City of Sandy

Planning Commission Meeting

Meeting Date: Monday, April 8, 2019

3. PUBLIC HEARING – Type III Subdivision for Jacoby Heights Subdivision (18-025 SUB/VAR/TREE/FSH/INT) Chairman Crosby opened the public hearing on File No. 18-025 SUB/VAR/TREE/FSH/INT (Jacoby Heights Subdivision) at 7:01 p.m. Crosby noted that this is a quasi-judicial public hearing. He called for any abstentions, conflicts of interest, ex-parte contact, challenges to the jurisdiction of the Planning Commission, or any challenges to any individual member of the Planning Commission.

- STREET TREE LEGEND**
- GREEN VASE ZELKOVA - SE JACOBY RD
 - GINKGO HALKA - NEWTON ST
 - VILLAGE GREEN ZELKOVA - MIDDLEBURY AVE
 - PATHMORE ASH - WOODSTOCK ST (SOUTH)
 - AMERICAN HOPHORNBEAM - WOODSTOCK ST (NORTH)
 - PAPERBARK MAPLE - CAMDEN CT

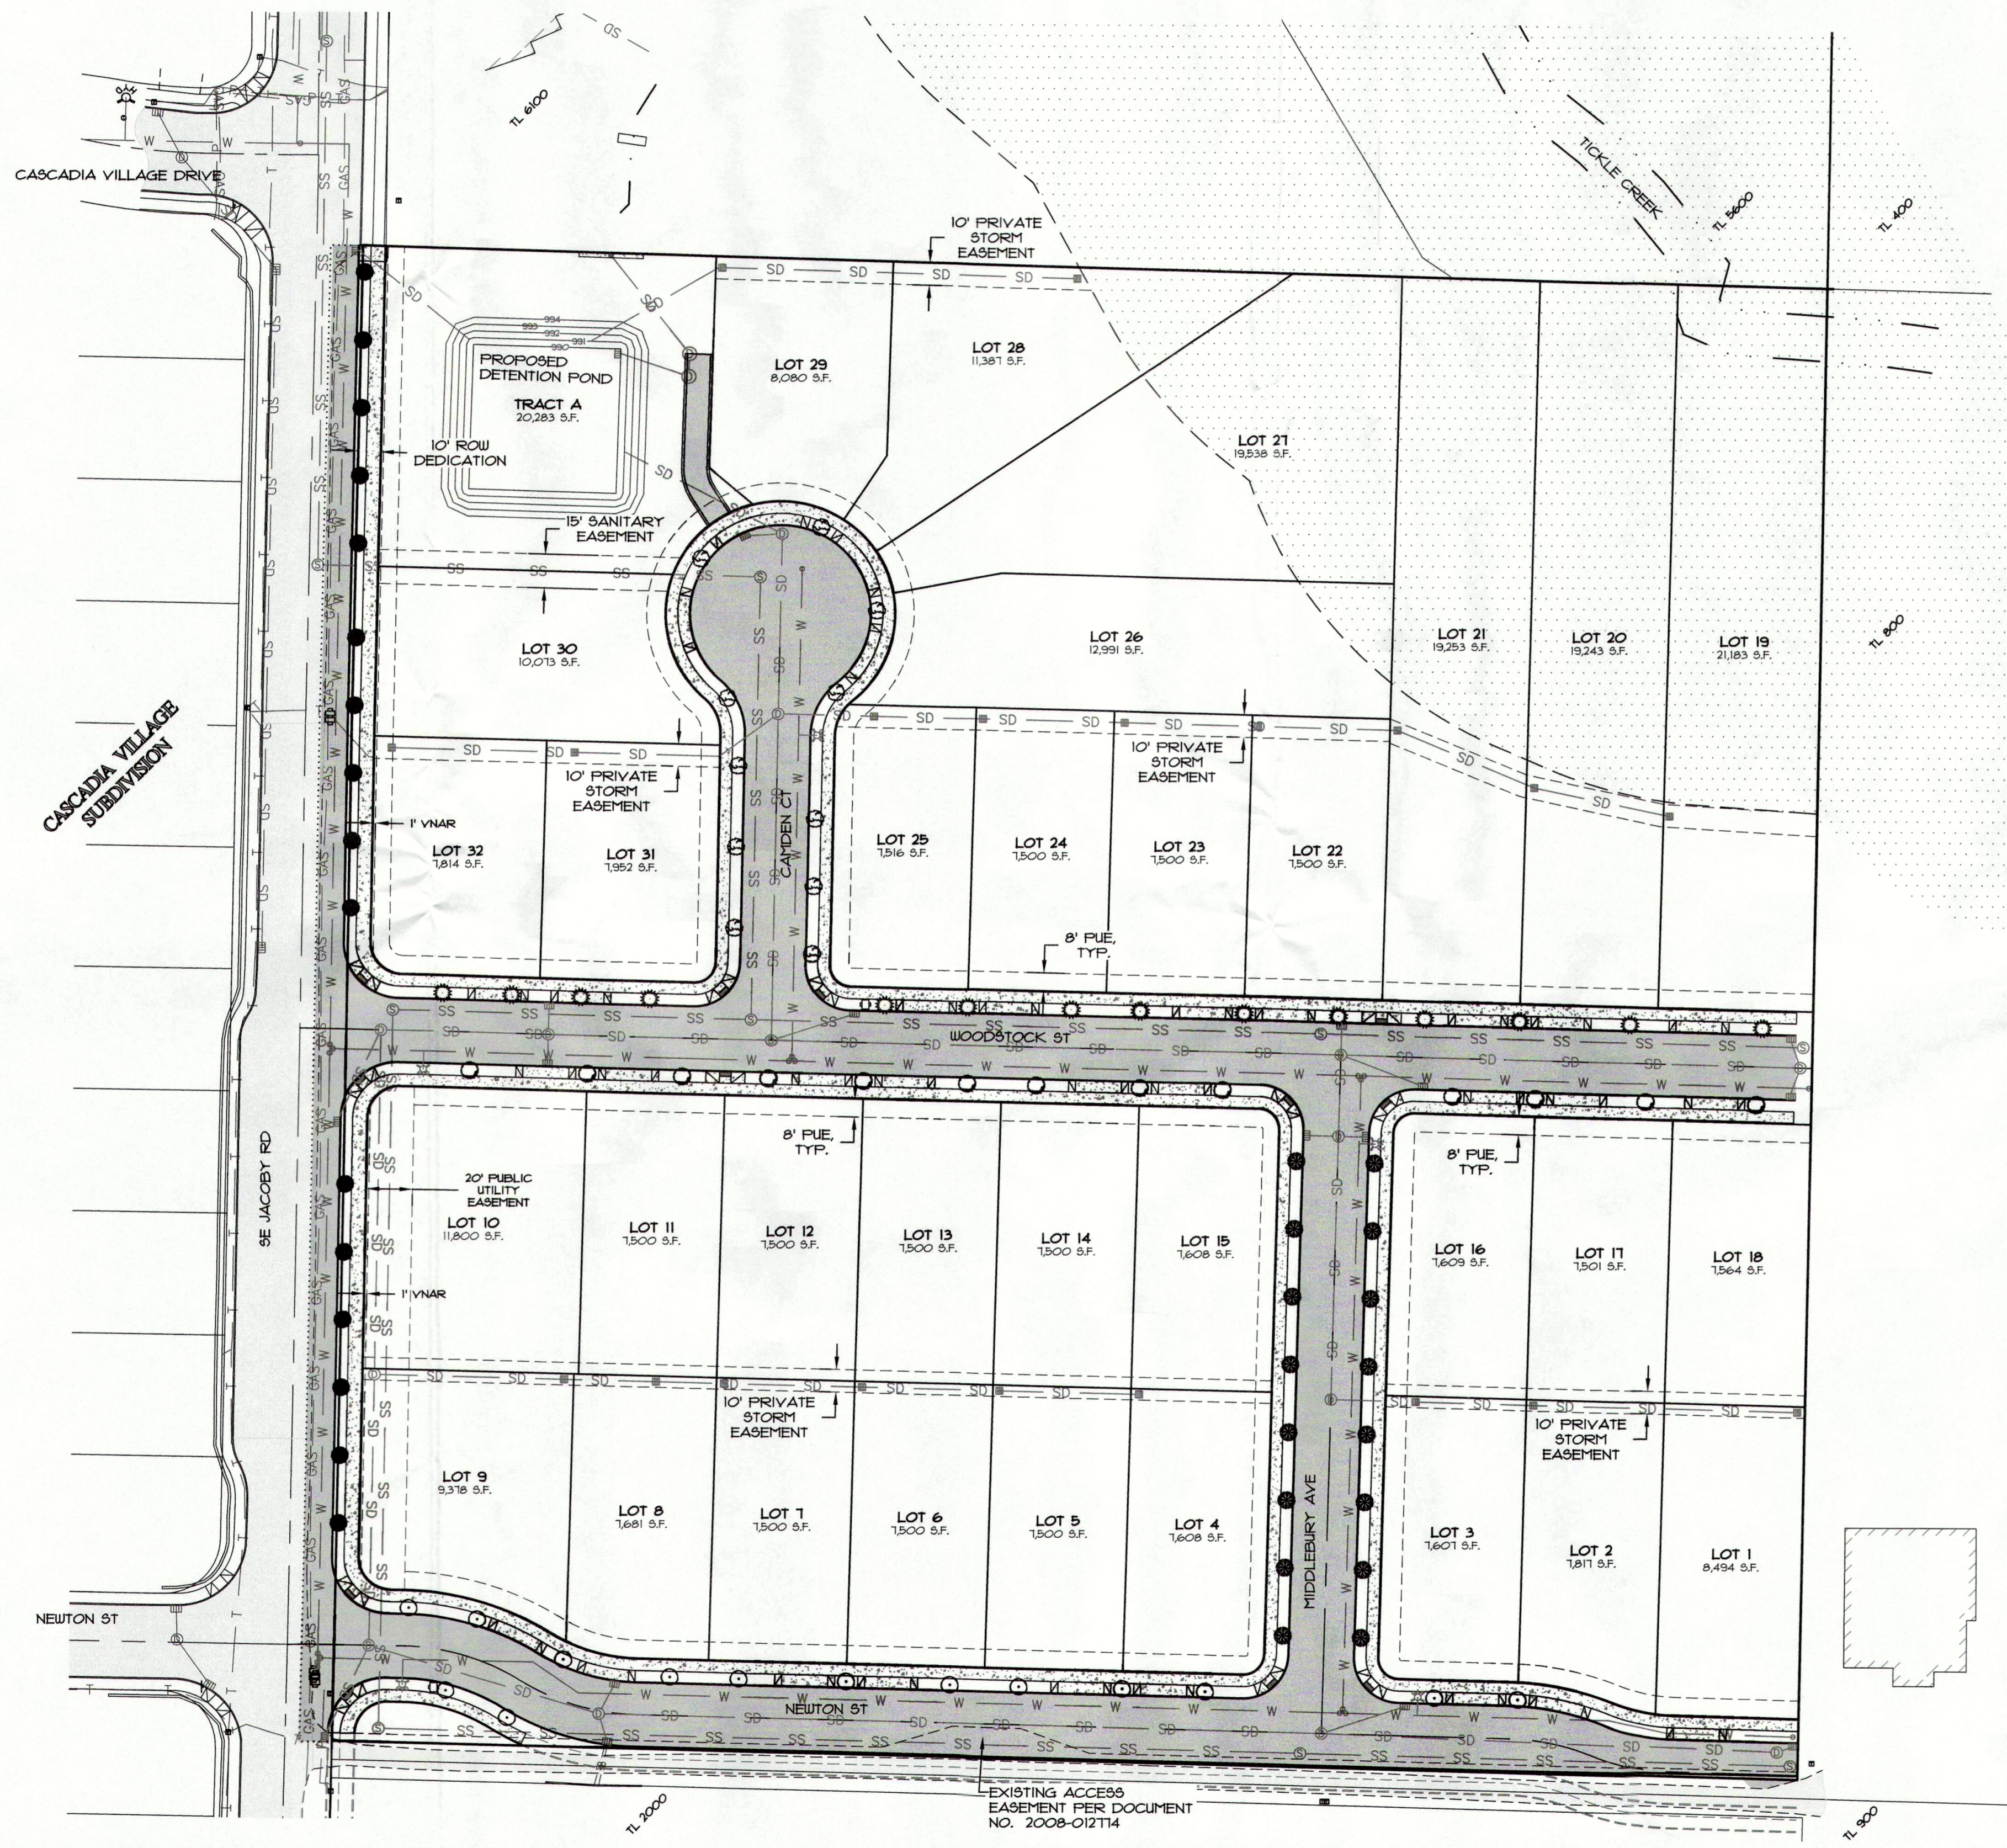
The submitted Street Tree Plan (Exhibit C, Sheet 6) identifies street trees along all streets. The section of Newton Street on the east side of the property adjacent to Lots 1 and 2 is proposed to be constructed with half street improvements. This proposed design places the utilities underneath the planter strip; thus, the proposal does not show street trees in front of Lots 1 and 2. Per the Public Works Director (Exhibit O), the applicant shall eliminate the proposed curve at the east end of Newton and continue the three-quarter street improvement to the east boundary of the site. The applicant shall provide the minimum three-quarter street improvements on Newton Street on the subject property or shall acquire land on adjacent properties to accommodate a three-quarter street. The applicant shall update the plan set to show street trees in the planter strip adjacent to Lots 1 and 2. Street trees shall be installed approximately 30 feet on center in conjunction with issuance of building permits. Street trees are required to be a minimum caliper of 1.5-inches measured 6 inches from grade. Trees shall be planted and staked per the City of Sandy standard planting detail; trees shall be tied to the stakes with loosely tied twine. The planter strip shall be graded and backfilled as necessary, and bark mulch, vegetation, or other approved material installed prior to occupancy. Tree ties shall be removed within one year of installation.

RESPONSE: *As required by Section 17.92.30, the development of the subdivision requires trees spaced 30 feet on center along street frontages. The submitted Street Tree Plan (Exhibit C, Sheet 6) identifies street trees along all of the proposed streets. The proposed plan details 84 street trees. Two (2) of the street trees are proposed to be located in driveways in front of Lots 31 and 32; however, there appears to be sufficient space to relocate at least one of the trees outside of the driveway area. **The applicant shall update the plan set to remove street trees from the driveways in front of Lots 31 and 32; at least one of the street trees shall be relocated outside of the driveway area.***

BY		SHEET	7
REVISION		OF	10
DATE		DESIGNED BY	CJH
		DRAWN BY	CJH
		CHECKED BY	RLT
		APPROVED BY	RLT

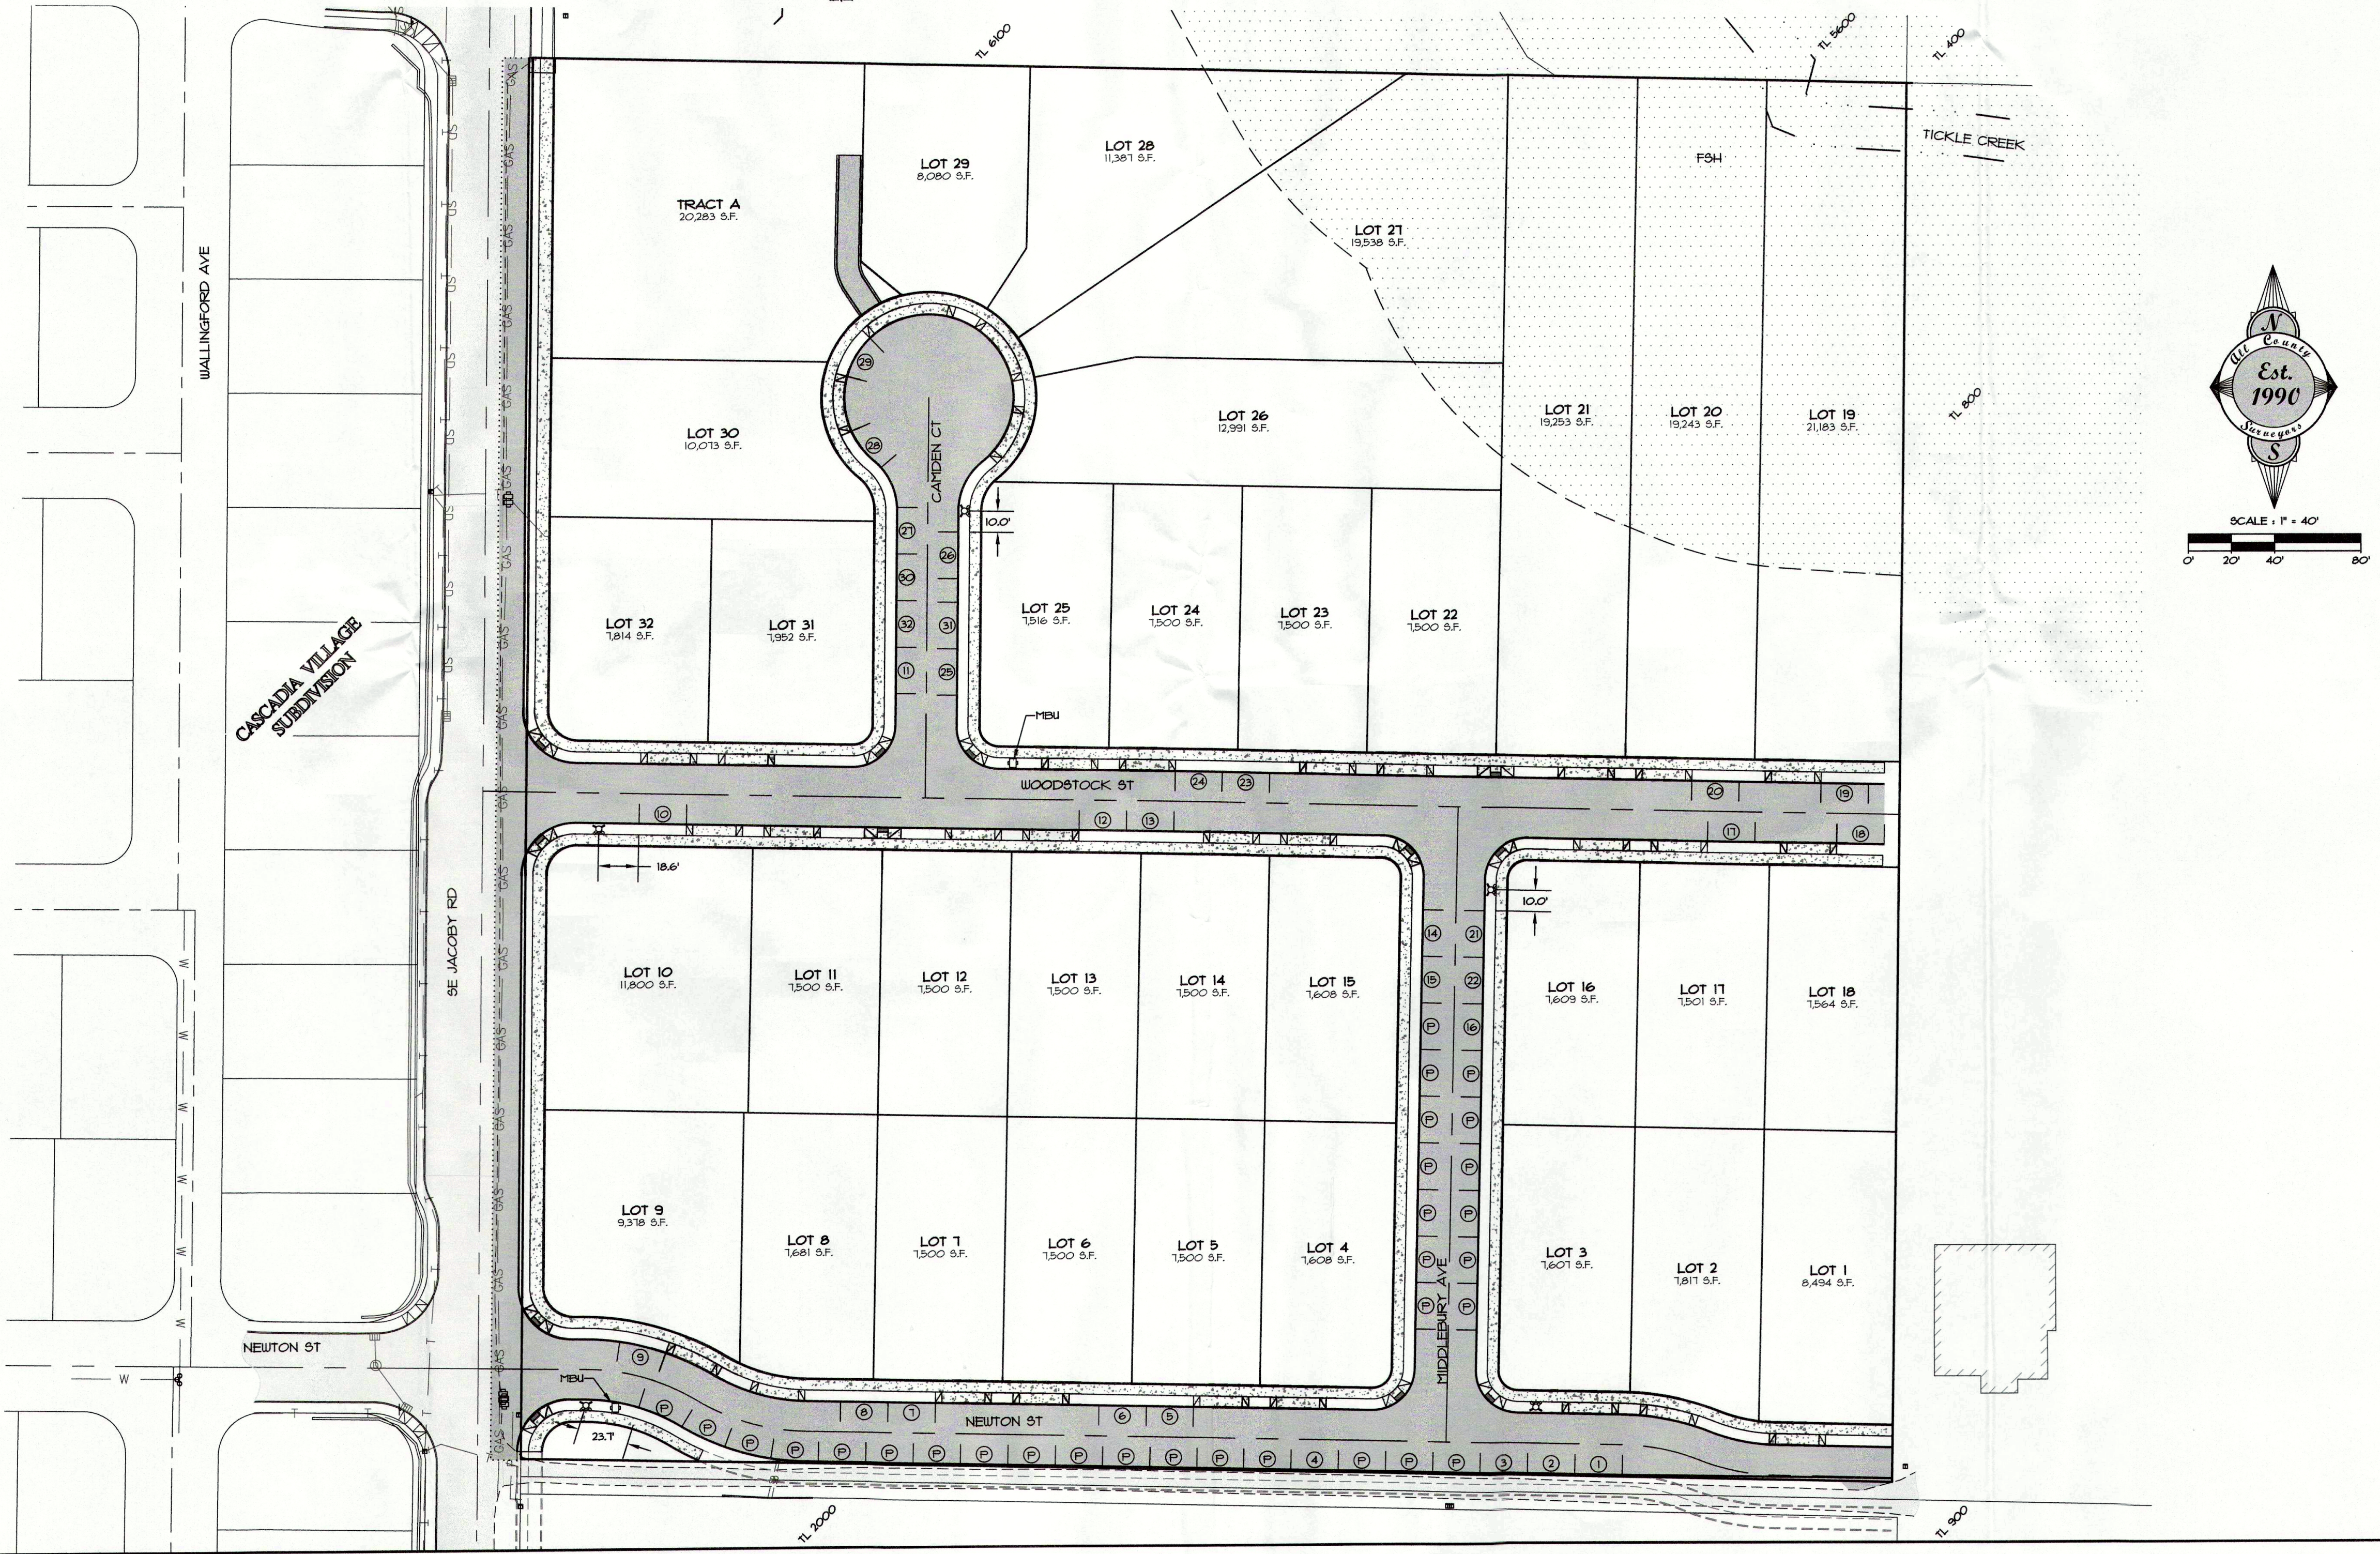
RESPONSE: *The minimum driveway width for a single-family dwelling is 10 feet. The Public Works driveway approach standard detail specifies a maximum of 24 feet wide for a residential driveway approach. The Preliminary Parking Plan (Exhibit C, Sheet 7) details driveway curb cuts for all lots. With the exception of a few lots on the cul-de-sac, all driveways are detailed at approximately 20 feet. The applicant is proposing a shared driveway between Lot 29 and Tract A at approximately 36 feet and a shared driveway between Lot 27 and 28 at approximately 26 feet. In order to maximize street tree planting areas and prevent conflicts with streetlights, water meters and dry utility facilities, shared driveway approaches may be required in cul-de-sac bulbs. Per the Public Works Director (Exhibit O), **Lot 28 and 29 shall share a driveway approach maximum 24 feet in width.***

RESPONSE: *The Preliminary Parking Plan (Exhibit C, Sheet 7) identifies a total of 62 on-street parking spaces with at least one (1) on-street parking space within 200 feet of each of the 32 lots. The proposed parking plan shows 21 parking spaces on the south side of Newton Street, including parking spaces for Lots 1-4. These on-street parking spaces should not be counted toward meeting the on-street parking requirement since the south side of the street will eventually develop with driveways and/or streets that will eliminate these spaces or prevent the developer of the site to the south from counting these spaces toward their on-street parking requirement. Per the Public Works Director (Exhibit O), **the applicant shall revise and resubmit the on-street parking plan for staff review and approval prior to final plat approval. No parking courts are proposed. The location of fire hydrants will be reviewed by the Sandy Fire Department in more detail with Construction Plans. The applicant shall revise the Parking Analysis if required fire hydrants affect on-street parking spaces.***
